**CITY OF BLOOMINGTON
PLAN COMMISSION AGENDA
Nov. 7, 2011 @ 5:30 p.m.**

**BLOOMINGTON PLAN COMMISSION
PRELIMINARY REPORT
LOCATION: 718-720 East 8th Street**

**CASE #: ZO-27-11
DATE: November 7, 2011**

PUD-28-11
Elevations

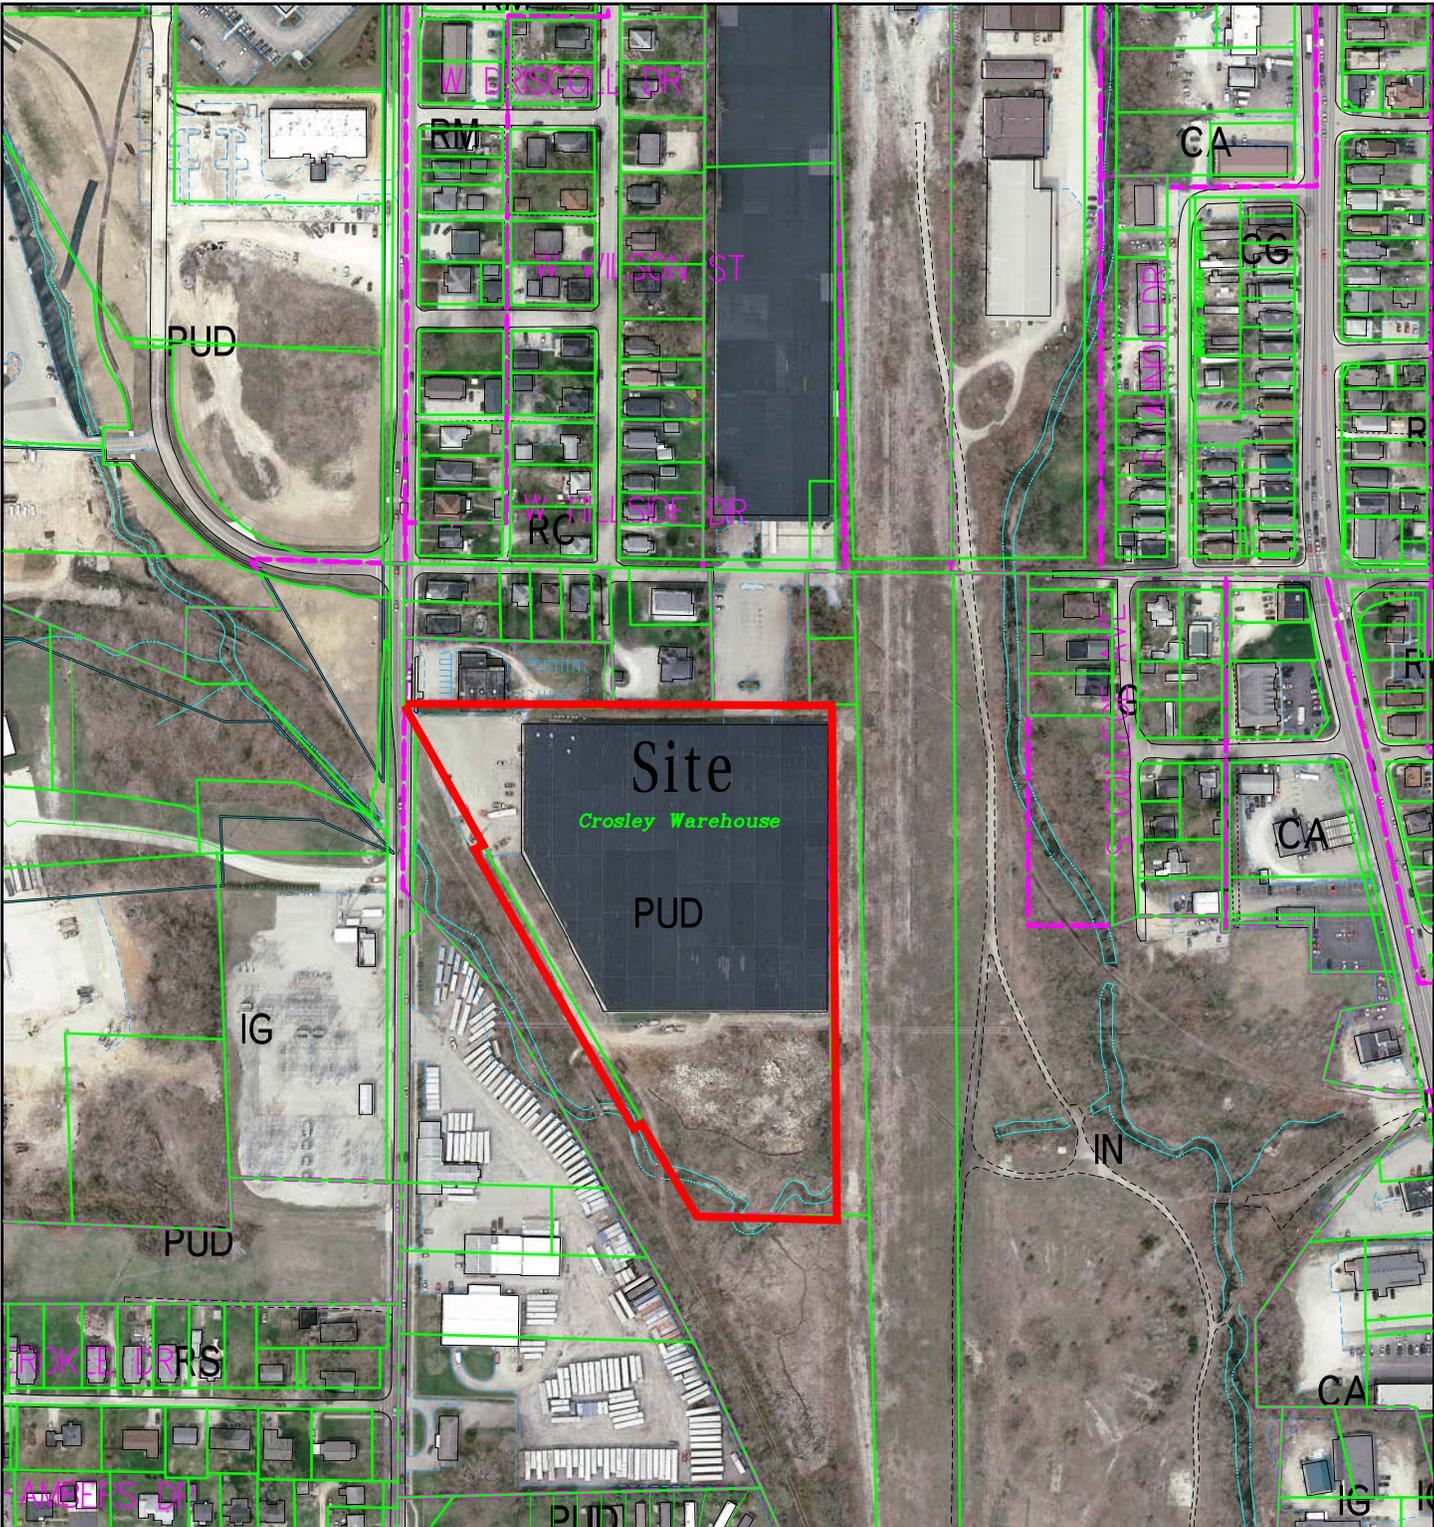
Architecture: The petitioner is proposing to refinish the entire exterior of the building on all four sides. New siding and finishing will be installed and will consist of limestone, brick, horizontal and vertical corrugated metal with split face block around the foundation. A list of allowable exterior materials has been proposed in the preliminary plan.

Height: The standard height for the CG districts is 50 feet. The petitioner is proposing to amend this limit to allow for a 55' tower on the west side of the building and a 74' tall flyloft for the theatre on the east side of the building. Staff requests guidance from Plan Commissioners on whether this proposed height increase is appropriate in a location that is approximately 70' from the B-Line Trail.

1. **Uses** – Does the Plan Commission agree with the list of permitted uses that has been submitted for this parcel? Should there be a cap on the maximum amount of space for an individual retail space?
2. **Architecture** – Is the proposed architecture appropriate? Does the Plan Commission have concerns regarding the height of the building and specifically the theater flyloft?

PUD-29-11
Site Plan

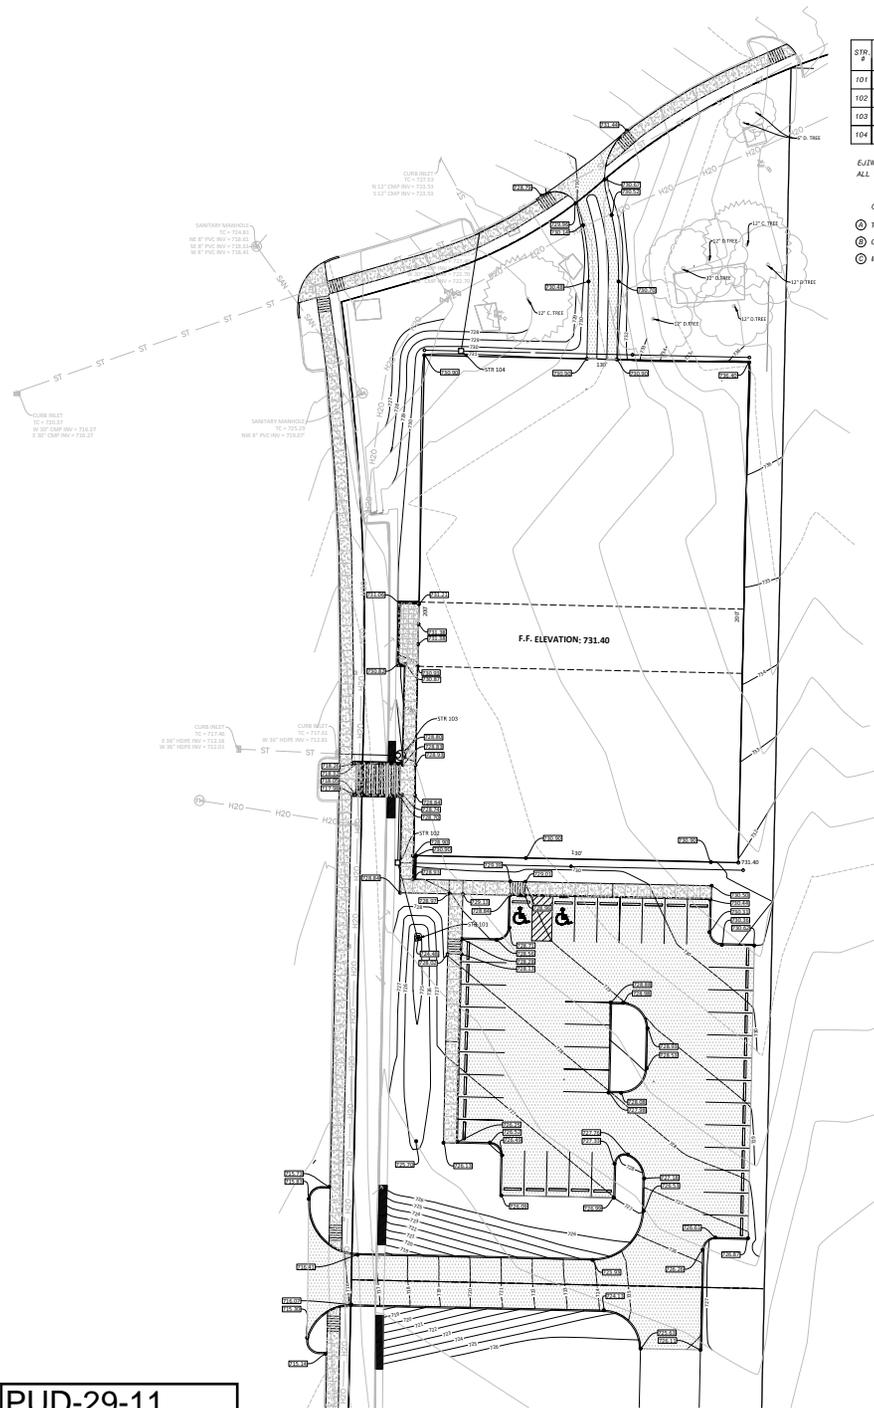
Regardless of whether City Utilities permits the ponds to count toward requirements for water quality, the UDO requires any parking lot of 16 spaces or more to either utilize pervious pavers or natural stormwater filtration (such as bio-swales or rain gardens) to filter parking lot run-off. The petitioners would like the existing Woolery Stone Mill ponds to count toward this requirement also. The Environmental Commission believes this requirement should be met on the site. In general, staff agrees with the Environmental Commission recommendation. Staff is seeking feedback from the Plan Commission on this issue.

1. **Uses** – Is a recreation center an appropriate use for this site? Is the use compatible with the already constructed uses in this PUD, the anticipated uses in Parcel I and the stated CAC policies of the GPP?
2. **Final Plans** – Does the petition contain enough details to allow delegation of the PUD Final Plan to staff level?
3. **Architecture** – Is the proposed architecture appropriate? Does the Plan Commission believe that the industrial aesthetic approved for the new mixed use buildings on the Wooley Mill site should be continued to Parcel I? If not appropriate, what changes should be made to the proposed building? At this point, Staff recommends that changes be made to the building to bring it more in line with the UDO architectural requirements.

WOOLERY PLANNED COMMUNITY PHASE IX (PRELIMINARY PLAT)

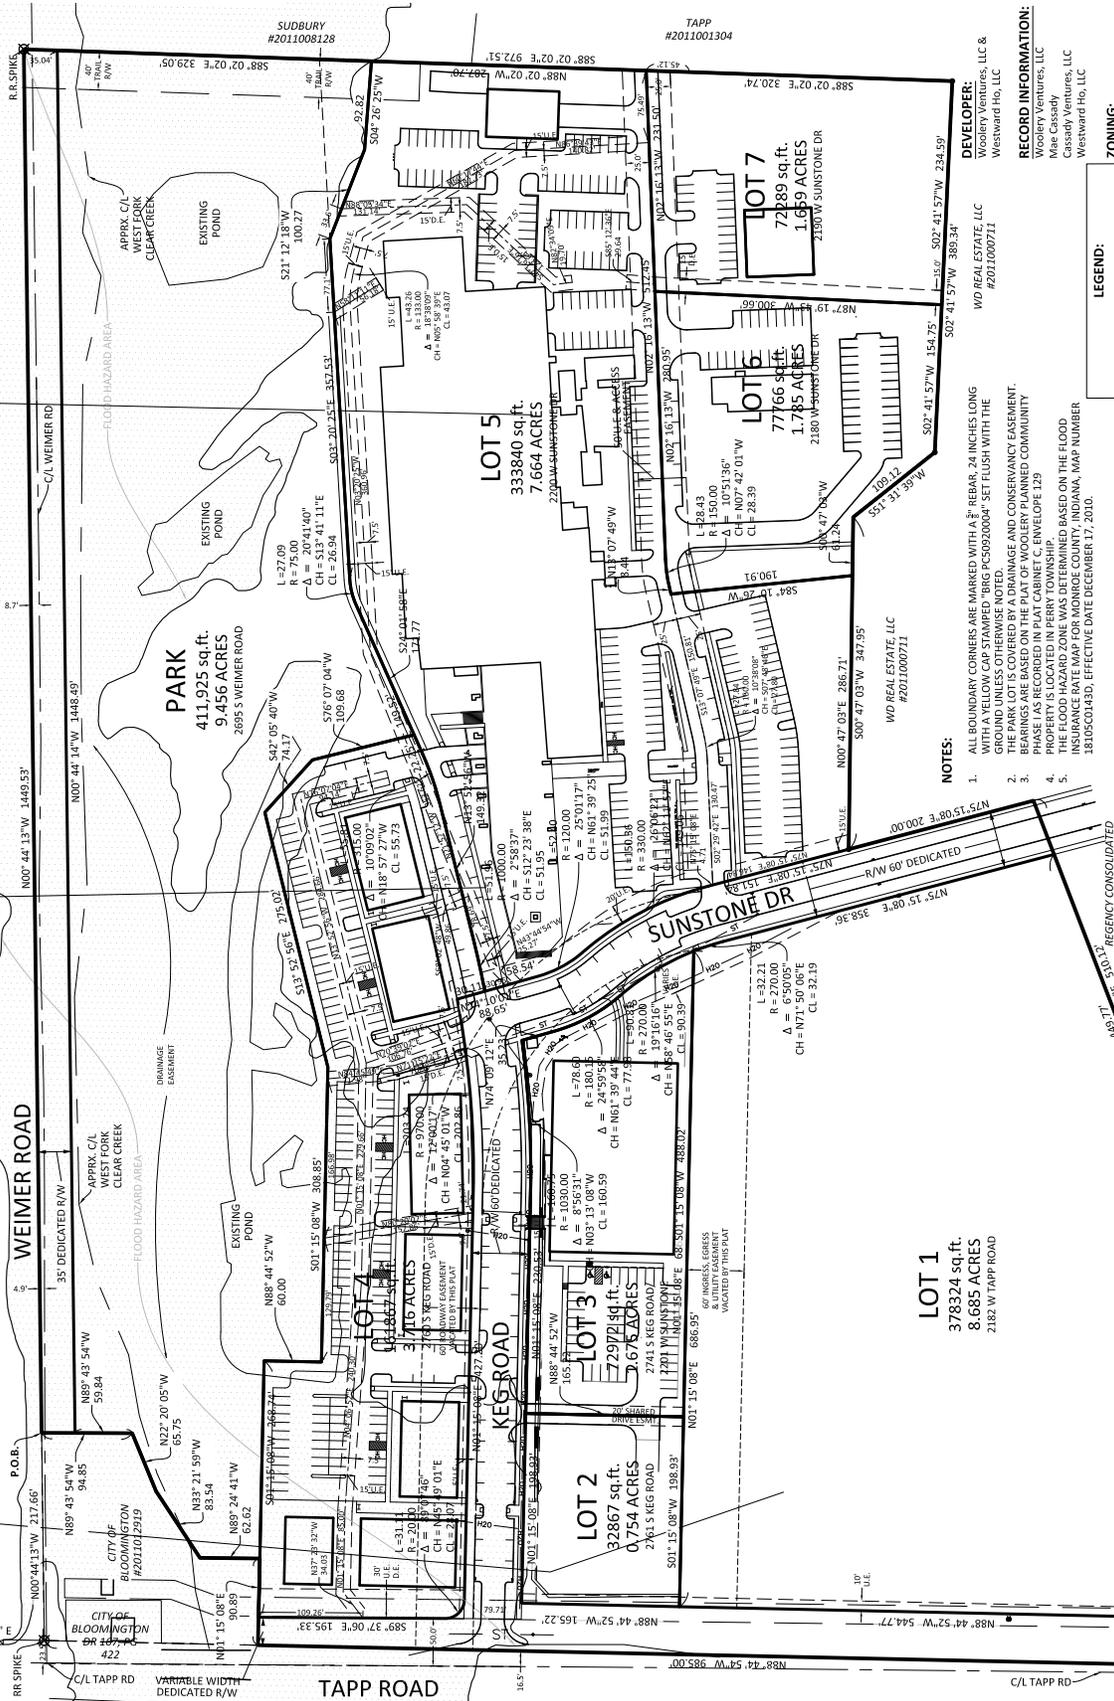
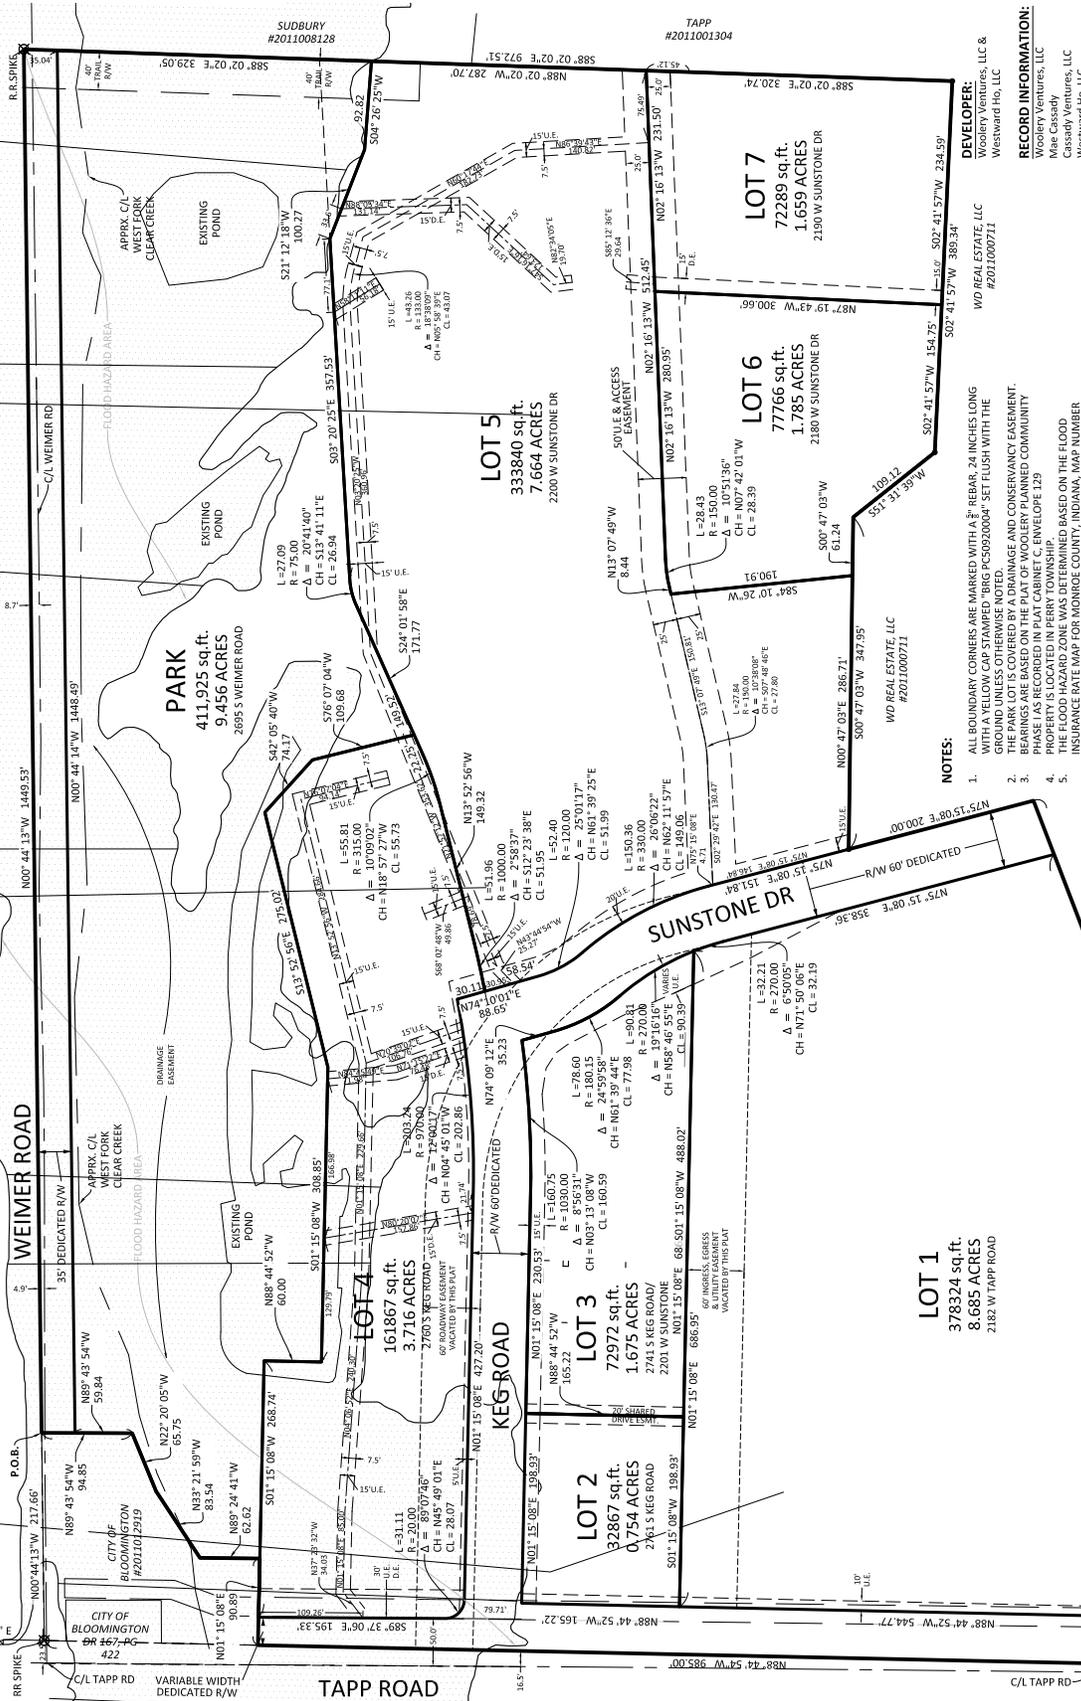
Preliminary plat discrepancies: There are parts of the proposed preliminary plat that do not match the actually constructed property. The petitioner's engineers are working on accurately surveying the property to ensure that there are no setback encroachments of other issues with the plat. In addition, the existing contour lines of Lot 1 and required street trees have not been indicated on the preliminary plat. A revised preliminary plat must be provided prior to the second hearing.

The west side of Keg Rd. was approved with a ten-foot wide sidewalk with street trees within tree grates as part of the PUD Final Plan. The approved buildings were to be built immediately at the edge of the right-of-way. Sidewalks and street trees are not yet shown on the preliminary plat.

The petitioner has requested deferral of bonding on the 10 foot wide sidewalk, street trees and tree grates on the west side of Keg Rd. This streetscape was required with the PUD Final Plan for the new construction which hasn't been built yet. The petitioner contends that because of the building design, with the structures built at the right-of-way line, that construction of the sidewalk and the buildings at the same time would be most efficient. Staff requests discussion by the Plan Commission on this issue. Absent Commissioner input, this request is supportable to staff.
